# Access Compliance Report

## Public Rights-of-Way

### (Curb Ramps)

Intersection ID: 7746	Main Street: ELGYWOOD_LN	Cross Street: W_ARROWHEAD_DR	Location: SE
ADA ID: 193DDB67FC8C	Ramp Type: Para	Initial Pass/Fail: Fail	Overall Compliance: No
		Severity Score: 12.5	
Codes/Mitigation Info/Possible Solution		Field Measurements/Component Compliance

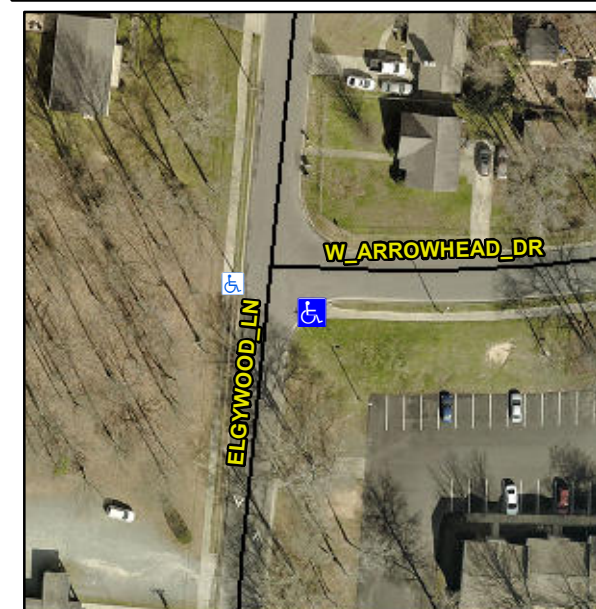
**Remove & Replace Entire Ramp.**

**R304.3.2**

Compliance	Description	Data	Compliance	Description	Data
N/A	Ramp Length LT (in)	40.5	N/A	Ramp Length RT (in)	56.5
Yes	Ramp Width LT (in)	77.0	Yes	Ramp Width RT (in)	59.5
No	Ramp Slope LT (%)	10.0	Yes	Ramp Slope RT (%)	6.9
Yes	Ramp XSlope LT (%)	0.8	Yes	Ramp XSlope RT (%)	0.3
N/A	Landing Length (in)	N/A	N/A	DWS Provided?	N/A
N/A	Landing Width (in)	N/A	N/A	DWS Contrast?	N/A
N/A	Landing Slope (%)	N/A	N/A	DWS Length (in)	N/A
N/A	Landing X Slope (%)	N/A	N/A	DWS Full Width?	N/A
N/A	Landing Curb? (Y/N)	N/A	N/A	DWS Offset (in)	N/A
N/A	Shared Landing?	N/A			
N/A	Gutter Ponding?	N/A	N/A	Gutter Slope (%)	N/A
N/A	Gutter Lip Ht (in)	2.0	N/A	Gutter X Slope (%)	N/A
N/A	Painted X Walk1?	No	N/A	Painted X Walk2?	N/A
	X Walk 1 Direction	To SW		X Walk 2 Direction	N/A
N/A	X Walk 1 Width (in)	N/A	N/A	X Walk 2 Width (in)	N/A
	X Walk 1 Slope (%)	2.6		X Walk 2 Slope (%)	N/A
	X Walk 1 X Slope (%)	1.7		X Walk 2 X Slope (%)	N/A
N/A	Ramp inside XWalk1?	N/A	N/A	Ramp inside XWalk2?	N/A
